Technical Service Bulletin

SUBJECT:
Ignition System
Cross Fire/Secondary
Ignition Wire Induction

NO: 18-48-98
GROUP: Vehicle Performance
DATE: Dec. 30, 1998

**FIGURE 1**

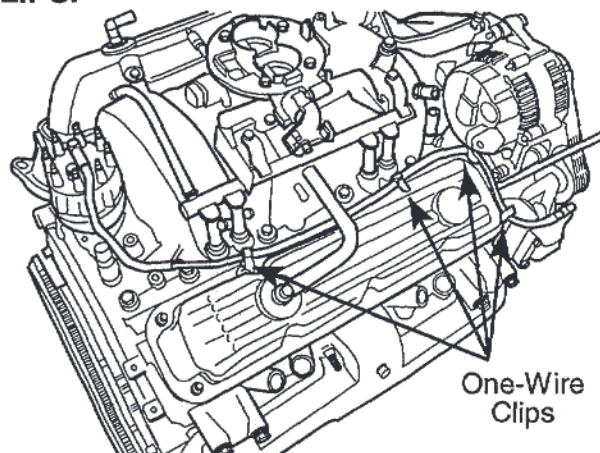
1. Coil Wire Routing (Figure 1 and 2)
 - A. Remove the coil wire from the distributor cap coil wire tower terminal.
 - B. Remove the coil wire from the rear five-wire clip, the center three-wire clip, and the front one-wire clip located along the lower side of the right valve cover.
 - C. Install three (3) one-wire clips p/n 56028186 along the top and front of the valve cover. Use the studs of the valve cover retaining bolts (Figure 1).

- D. Route the coil wire starting from the ignition coil toward the distributor. Any excess wire should end up at the distributor end.
- E. Install the coil wire into the one-wire clips. This procedure may be easier to perform while the coil wire is loose from the valve cover (before the one-wire clips are attached to the valve cover studs).

- F. Cut the ignition wire convolute p/n 04364375 into three lengths 203 mm (8 in.), 101.5 mm (4 in.), and 82.5 mm (3.25 in.).
- G. Slit and install the three sections of convolute onto the coil wire between the one-wire clips. Install the 82.5 mm (3.25 in.) section at the front of the right valve cover. Install the 203 mm (8 in.) and the 101.5 mm (4 in.) sections along the top side of the right valve cover. This procedure may be easier to perform while the coil wire is loose from the valve cover (before the clips are attached to the valve cover studs).

FIGURE 2

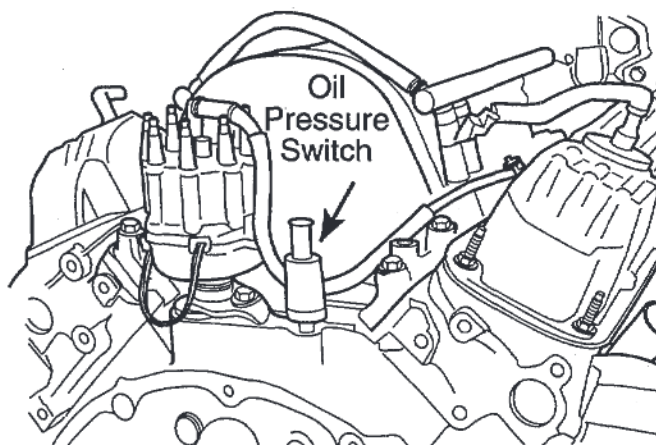
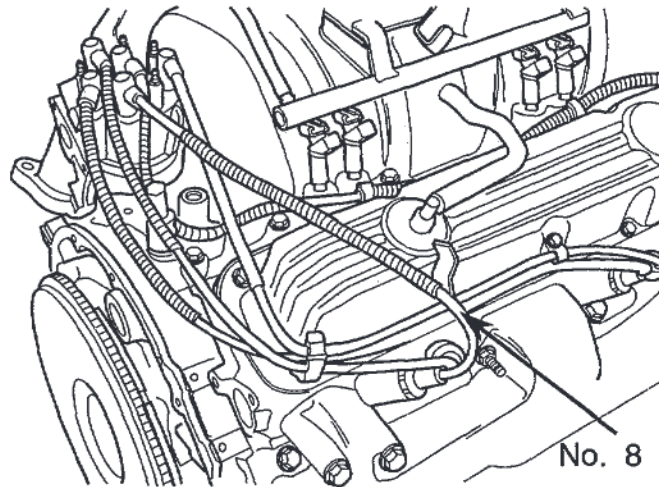
- H. Route the distributor end of the coil wire down and behind the intake manifold, in front of the oil pressure switch (Figure 2).

NOTE: THE COIL WIRE MUST BE A MINIMUM OF ONE (1) INCH AWAY FROM ANY OTHER IGNITION WIRES. THIS MAY REQUIRE THAT THE COIL WIRE BE ROUTED UNDER VACUUM AND/OR WIRE HARNESSSES IN THE RIGHT REAR CORNER OF THE INTAKE MANIFOLD.

- I. Route the distributor end of the coil wire up the side of the distributor cap and onto the coil wire tower terminal.
- J. Position the original piece of coil wire convolute so it protects the wire against chafing with components at the rear of the engine.

FIGURE 4

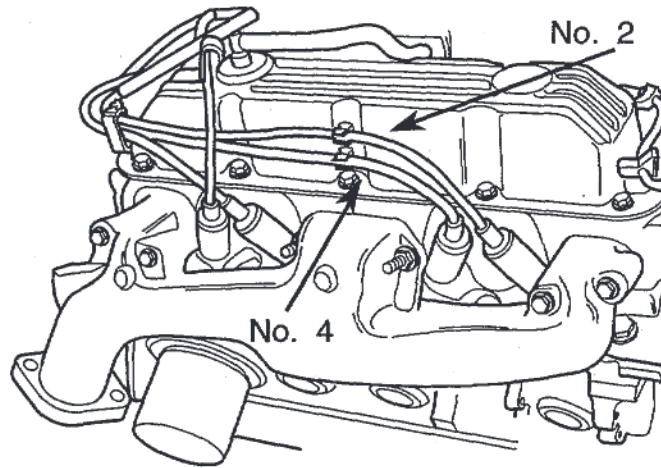
3. No. 4 Cylinder Plug Wire Routing (Figure 4 and 5)

- A. Remove the No. 4 cylinder plug wire from the distributor cap terminal.
- B. At the three-wire clip (located at the center of the lower side of the right valve cover), keep the two wires from crossing and chafing each other. Position the No. 2 cylinder plug wire in the top wire slot and the No. 4 cylinder plug wire in the bottom wire slot. Leave the middle wire slot empty (Figure 5).

FIGURE 5

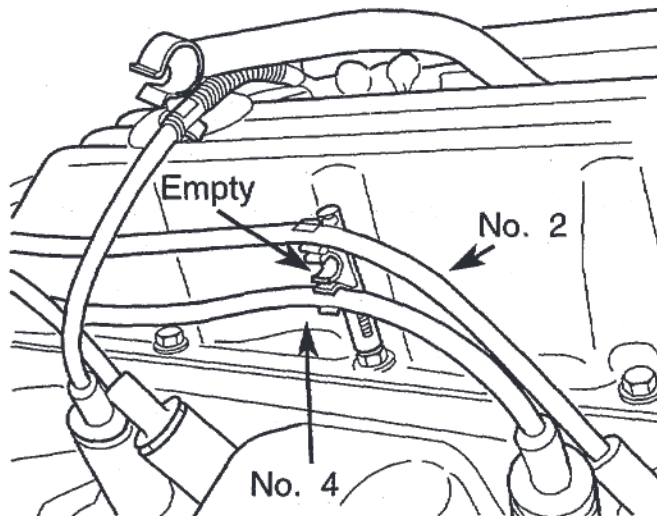
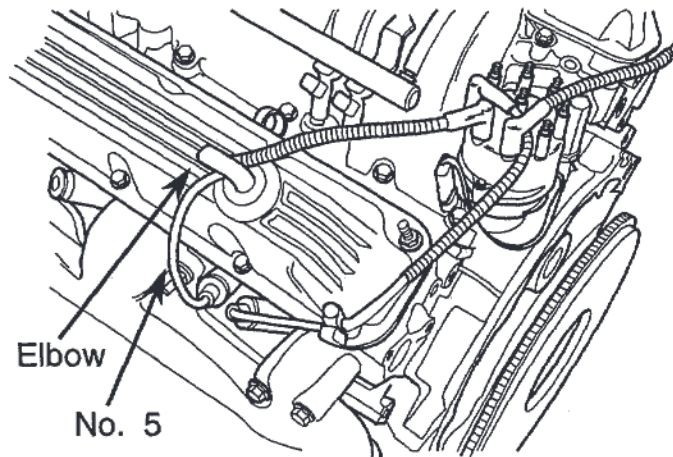
- C. At the five-wire clip (located at the right rear lower side of the valve cover), keep the plug wires from crossing and chafing each other. Position the No. 4 cylinder plug wire in a slot that will obtain the maximum amount of distance allowable from the No. 8 cylinder plug wire (Figure 6). Remove any slack in the No. 4 cylinder plug wire between the three-wire and the five-wire clips.

FIGURE 11

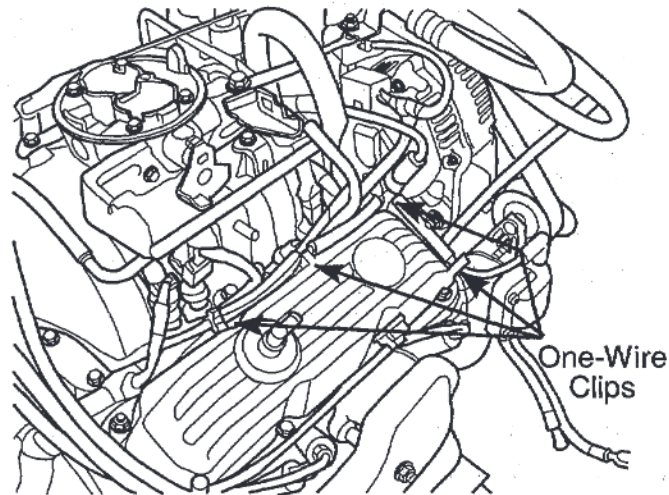
- C. Install three (3) one-wire clips p/n 56028186 along the top and front of the valve cover studs (Figure 11).

- D. Route the coil wire starting from the ignition coil toward the distributor. Any excess wire should end up at the distributor end.
- E. Install the coil wire into the one-wire clips. This procedure may be easier to perform while the coil wire is loose from the valve cover (before the one-wire clips are attached to the valve cover studs).

- F. Cut the ignition wire convolute p/n 04364375 into three lengths. Two (2) at 101.5 mm (4 in.), and one (1) at 82.5 mm (3.25 in.).
- G. Slit and install the three sections of convolute onto the coil wire between the one-wire clips. Install the 82.5 mm (3.25 in.) section at the front of the right valve cover. Install the two 101.5 mm (4 in.) sections along the top side of the right valve cover. This procedure may be easier to perform while the coil wire is loose from the valve cover (before the clips are attached to the valve cover studs).

FIGURE 12

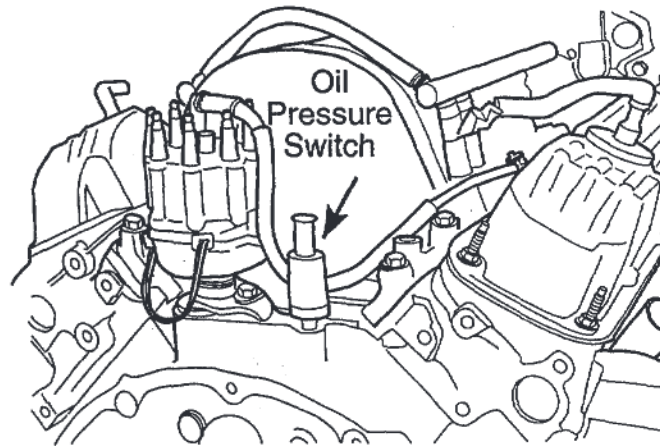
- H. Route the distributor end of the coil wire down and behind the intake manifold, in front of the oil pressure switch (Figure 12).

NOTE: THE COIL WIRE MUST BE A MINIMUM OF ONE (1) INCH AWAY FROM ANY OTHER IGNITION WIRES. THIS MAY REQUIRE THAT THE COIL WIRE BE ROUTED UNDER VACUUM AND/OR WIRE HARNESSSES IN THE RIGHT REAR CORNER OF THE INTAKE MANIFOLD.

- I. Route the distributor end of the coil wire up the side of the distributor cap and onto the coil wire tower terminal.
- J. Position the original piece of coil wire convolute so it protects the wire against chafing with components at the rear of the engine.
